| P.O Telecomms HQRS | Ε | | | | | |

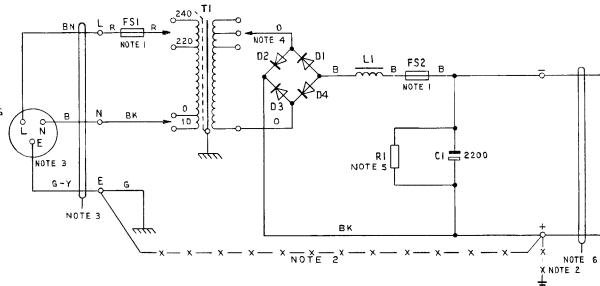
| P.O Telecomms HQRS | Ε | | | | | |
|--------------------------|------|---|--|---------------------------------|---------|--|
| PAPER:- W | 1550 | G | NEW FORMAT. TRANSFORMER 2009 TAPPING REMOV CAPACITOR VALUE CHANGED NOTES 2,3,4 &6 AMENDED | ED. WIRE COLOURS & DLW TD 7.2.3 | 31-1-77 | |
| DISTN:- General | | F | EARTH WIRE SPECIFIED | кма | 7-3-68 | |
